Reference: 23082

Re: 54-58 Beaconsfield Street, Newport – Traffic Response to RFI

I have considered the relevant traffic and parking matters contained in Council's RFI (2023/1869) of 9 April 2024.

WARNING
THE LOCATIONS OF UNDERGROUND SERVICES
ARE APPROXIMATE AND BASED ON SITE.
THE EXACT LOCATIONS ARE DETERMINED ON SITE.
ALL EXISTING SERVICES SHOWN ARE NOT GUARANTEED.

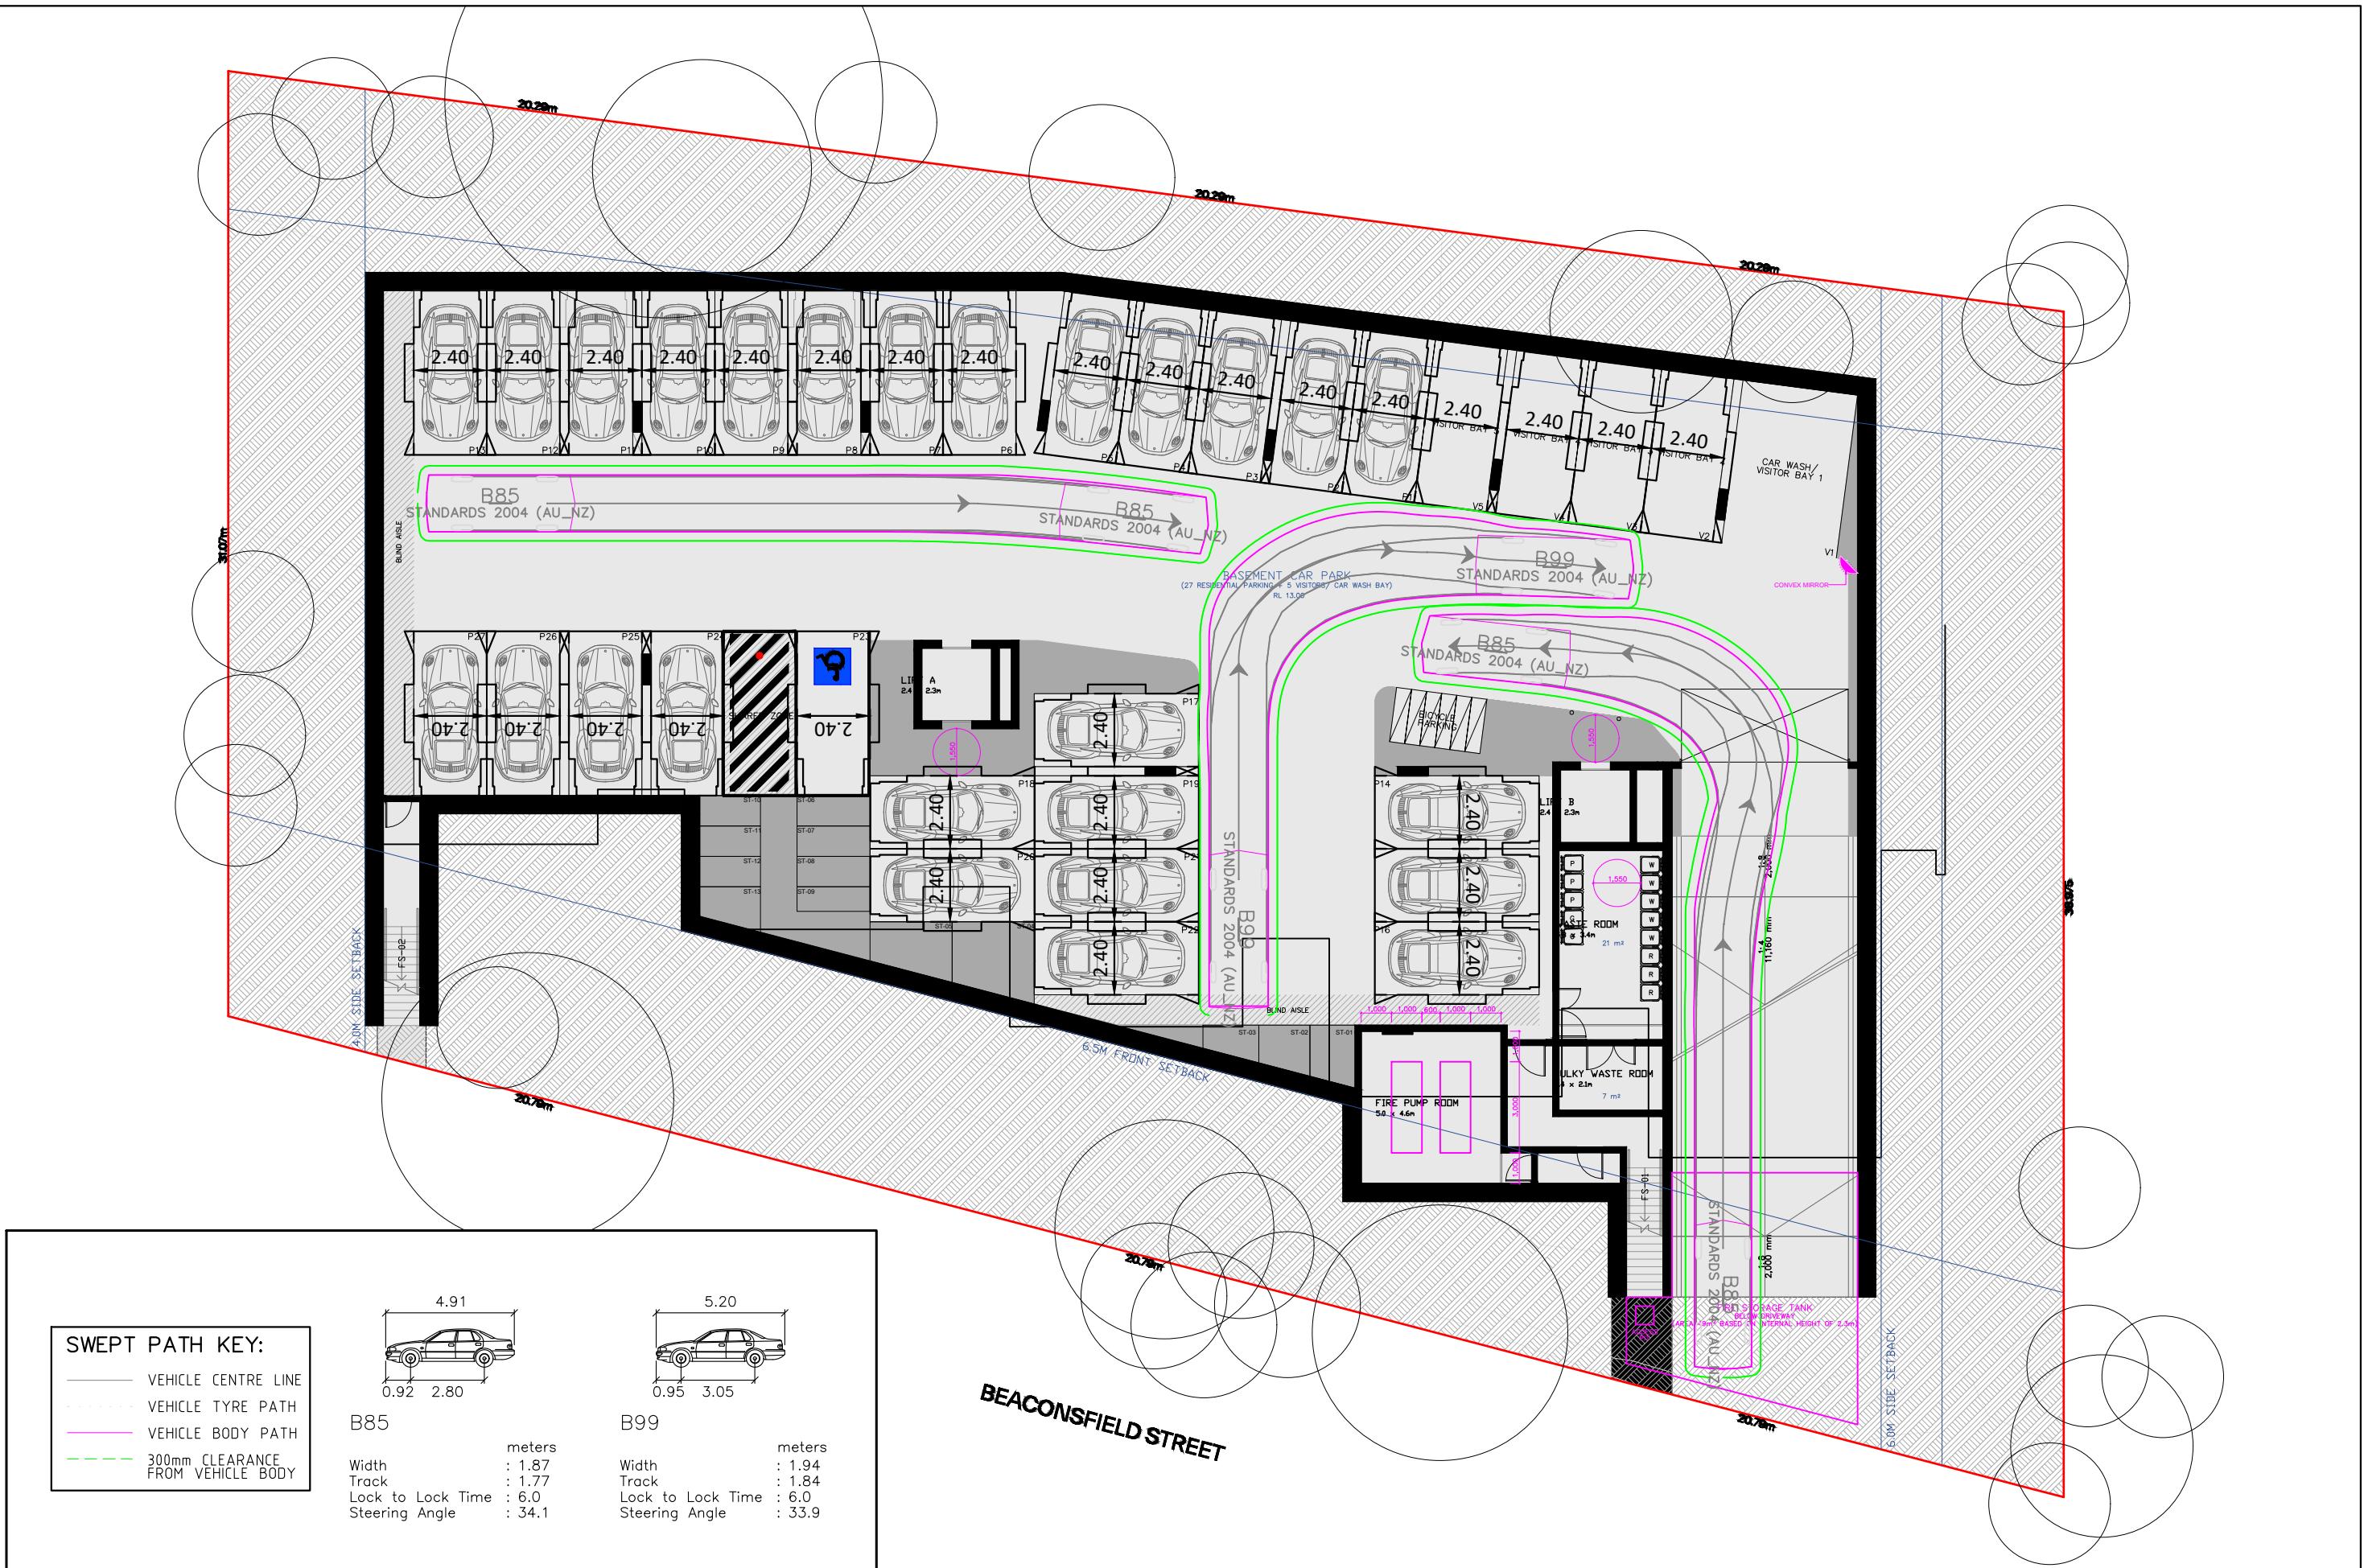
In page 28 of the Traffic Report, swept path for B85 passing B99 at the bottom of the ramp are overlapping each other. This means there is no passing achieved. Passing should either be achieved or if not possible, a stop holding line must be provided for vehicles exiting the basement, giving way to the entering vehicles. Swept paths must be amended and provided to Council's satisfaction.

In page 29 of the Traffic Report, a simultaneous passing of B85 and B99 is shown. However, the bodies of two vehicles are overlapping each other. This means there is no simultaneous passing achieved. This page should be amended for compliance with AS2890.1

The design did not intend for opposing vehicles to pass one another concurrently. For this reason, convex mirrors have been denoted on the plans, as is typical for residential car parks of this nature. The revised swept path diagrams appended to this statement indicate with clarity the available passing opportunity for vehicles in both directions.
